**APPENDIX 2 - AMENDED VERSION OF THE PC52 PROVISIONS, SHOWING
TRACKED CHANGES**

12.21 Mount Cardrona Station Special Zone

Mount Cardrona Station Limited

Requested Plan Change – November 2016

NOTE: Operative versions of Structure Plans A – D have been deleted. Proposed versions have been inserted as follows

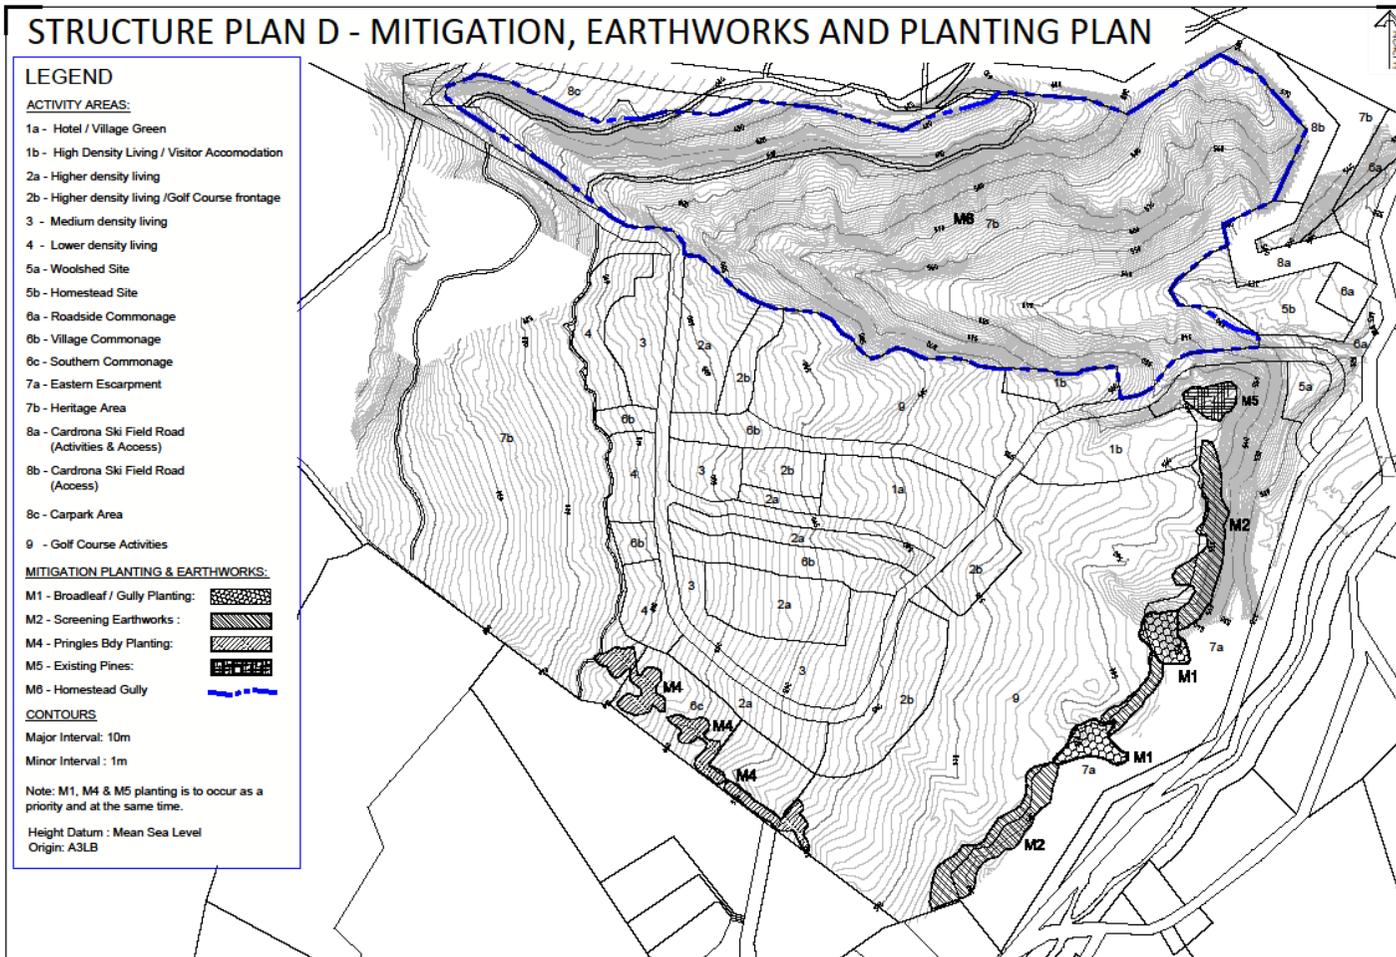
Comment [DCL15]: I have just picked up that this plan has removed the public easement in gross from AA6c. There is no assessment of this as far I can see in either the Requestor's s32 or the s42A report. I am not sure about the background to this. It could potentially limit access from Pringles Creek Road.
